Removal of Inner 5/8" Type X Drywall Requirement

Figure 1: Framing Installation without Inner 5/8" Type X Drywall Layer

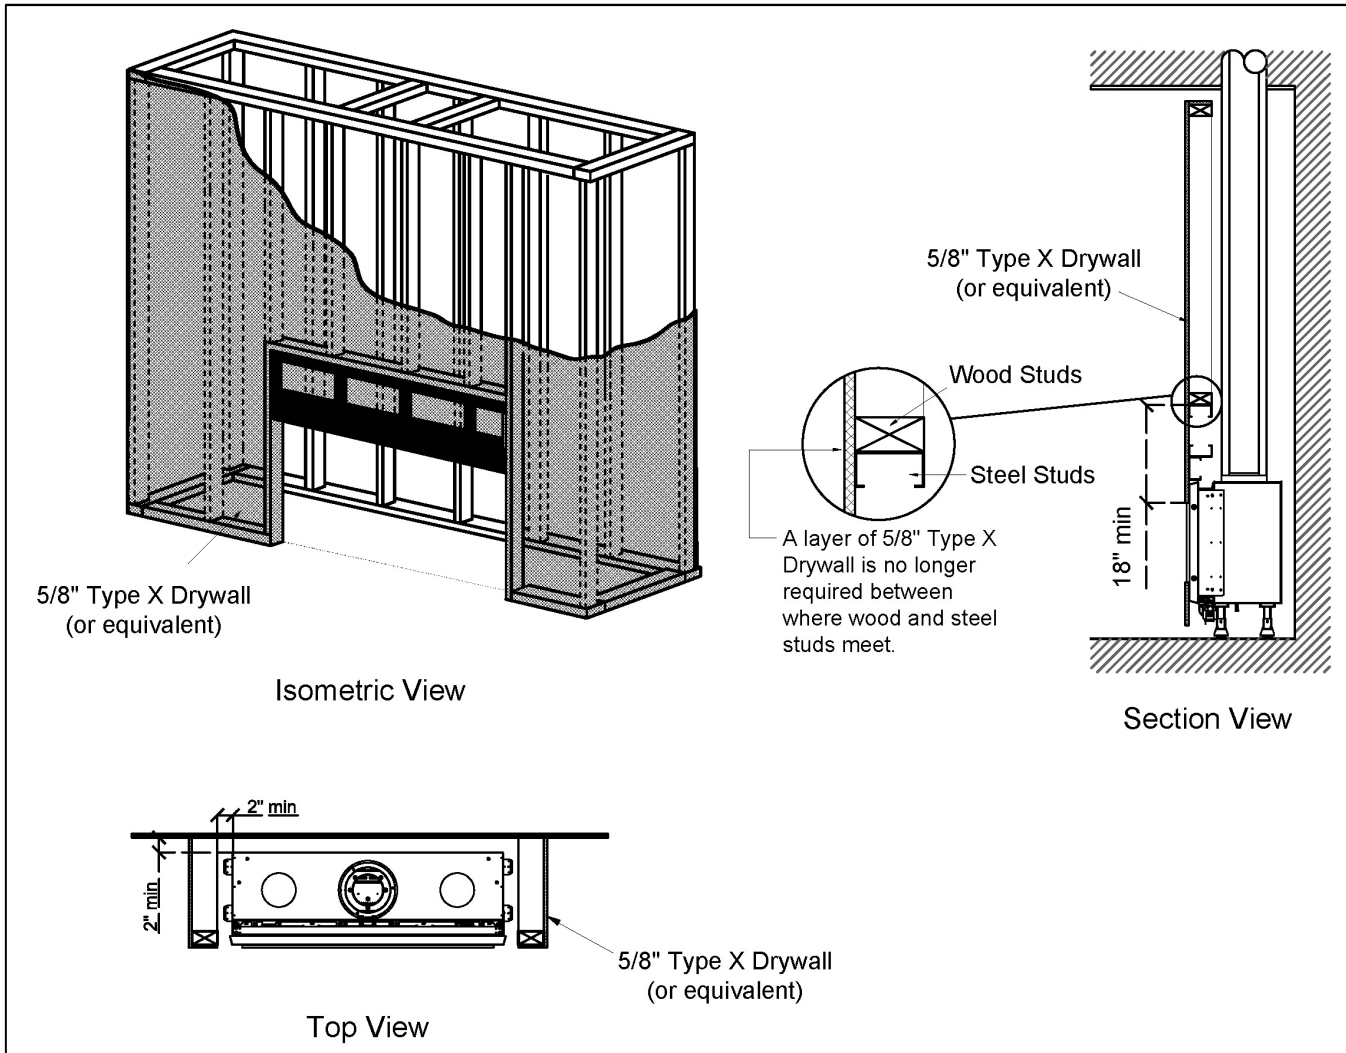
We are happy to announce that Ortal, Lyric, and Wilderfire fireplaces are approved to be installed without an inner layer of 5/8" Type X Drywall inside the chase. This approval applies to all Ortal-manufactured built-in fireplaces sold in the North American market, with exception of the Ortal Traditional 90 & 110 that do not have easy-installation stand-offs (pre-serial #29730).

The temperatures inside the cavity can reach up to 90°F above room temperature and the appliances are meeting these criteria and approved by CSA with no requirement to use the inner layer of 5/8" Type X Drywall.

Figure 1 below illustrates framing installation without the inner layer of 5/8" Type X Drywall inside the chase.

All other framing and building requirements remain unchanged.

We will be working to update all our manuals and technical documents with this information. In the meantime, this document serves as official approval letter to permit installations that follow these new installation instructions. This document is retroactive and supersedes all current and previous manuals.
